CAIRNGORMS NATIONAL PARK AUTHORITY

Title: PROPOSED BEAULY - DENNY 440KV TRANSMISSION LINE : UPDATE AND REVISION TO (SSE) PREFERRED ROUTE.

CAIRNGORMS NATIONAL PARK AUTHORITY PC Paper 5, 28 Jan 2005

Figure 1: Map showing original route options, with link to new route shown dashedred; from there the new dark blue route takes the line further north from Dalwhinnie, joining onto the green line which then follows the eastern side of the A9 south. (Park boundary shown pale-yellow).

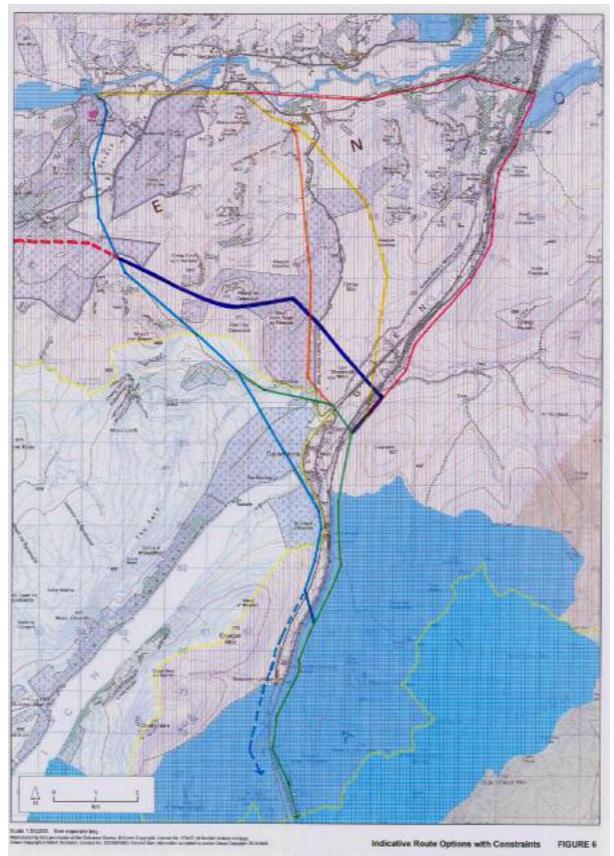
- 2. The last consultation asked us to comment on a range of five possible routings between Laggan and Dalwhinnie, but we felt we could not comment without detailed information on route visualisation, and potential impacts on communities, environment and landscape. These routes are shown in Figure 1 above, to which I have added an alteration to the blue route, and a connection to the amended route via Glen Shirra. The alteration to the blue route, shown darker blue, takes the point at which the transmission line crosses Glen Truim north of Dalwhinnie by approximately 1km, then follows the 'green' route south on the eastern side of the A9. This should alleviate many of the concerns of the Dalwhinnie community.

- 3. Relative to the area shown on Figure 1, two principal concerns still remain: the impact on the landscape when crossing the open moorland of Glen Truim; and the impact on the Drumochter SPA and cSAC(SCI). Issue one could possibly be addressed by undergrounding (see section 13) and the designated sites should be fully addressed by the Environmental Statement.

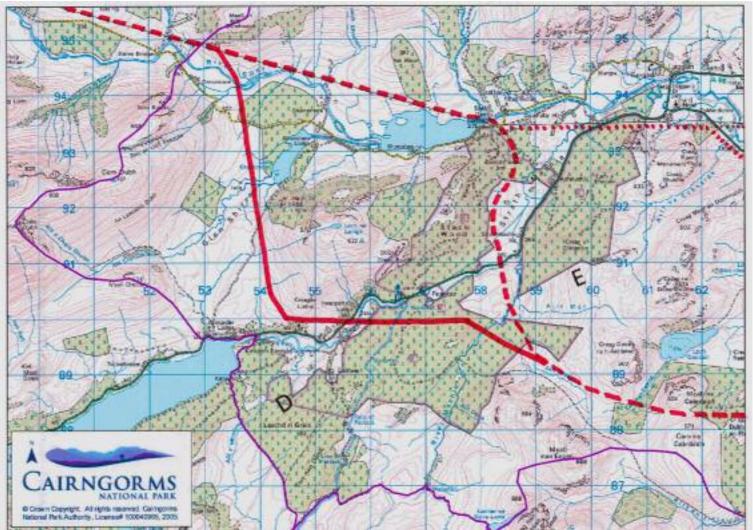
- 6. The new alternative which has been proposed, see Figure 2, is to take the line down Glen Shirra to a point approximately 0.5km east of Kinloch Laggan, crossing the A86 south of Inverpattack Lodge, and then re-joining the old preferred route some 2km south of Strathmashie House. This new route takes the line away from the Fort, Strath Mashie and the general Laggan community area. Where the new route would cross the A86, views are much more restrictive than in Strath Mashie, due to the winding road, topography and tree cover. Visualisation of the line, from the western A86 approach along Loch Laggan, may however be an issue.

- 7. From visiting the various sites and viewpoints, it would initially appear that this alternative route will be less intrusive on the landscape than the previous one, and certainly less visible from the A86; the approach from the west will most likely view the pylons against a hillside backdrop. The new routing also takes away the impact on cultural heritage at Dun da Lamh Fort, which is one of the prime historic sites within the Park. There are also less houses along/in sight of this route, thus reducing the impact on local communities. Visualisation, through photo-montages, will show whether the line is visible from the tourist/community areas at the eastern end of Loch Laggan.

- 17. On paper, the revised route via Glen Shirra would appear to avoid the specific cultural and landscape problems which were caused by the previous route around Dun da Lamh Fort and Strath Mashie, but we cannot fully comment without much more detailed information on route-visualisation and assessment of the impacts on the environment, landscape and local communities. The issue of the line passing through a National Park is one which is of significance to the whole nation and decisions cannot be taken lightly; equally, mitigation measures should be the highest priority to alleviate the impacts on communities, the environment and the landscape.
